RE: Sunoco Pipeline, L.P. (SPLP) – Pennsylvania Pipeline Project
Scenic Rivers Review- 2015: Applicant Code 805.
Minor Modification of Workspace at LeTorte Spring Run, Cumberland County, PA

ATTACHMENT 1

AERIAL FIGURE OF WORKSPACE FOR LETORTE SPRING RUN WATER WITHDRAWAL

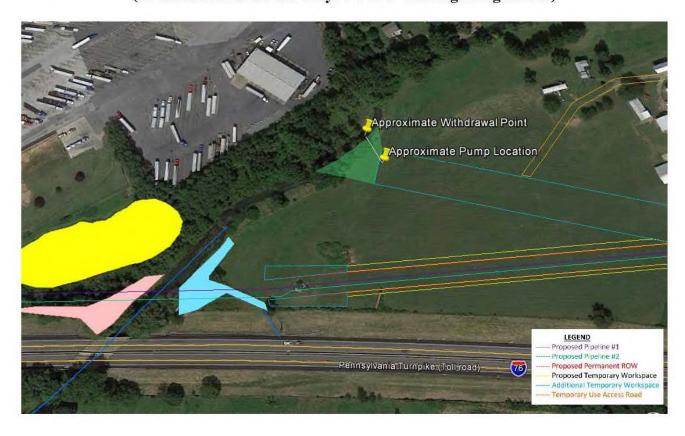
Specifically, the proposed temporary access site would be used for access to the stream, placement of a water pump (with secondary containment if within 50 feet of the stream), and temporary overland piping. The water pump would be placed within the surveyed limits of disturbance (LOD) and temporary overland piping would run across the area (marked in green) to the stream, where a total of 388,708 gallons of water would be withdrawn. No tree or shrub clearing will be required in this area, temporary erosion and sedimentation controls would be installed as required, and any disturbed areas would be restored and seeded following completion of this temporary use.

Pennsylvania Pipeline Project Proposed Workspace at LeTorte Spring Run (Green Area is for Access Only. No Tree Clearing Along Stream)
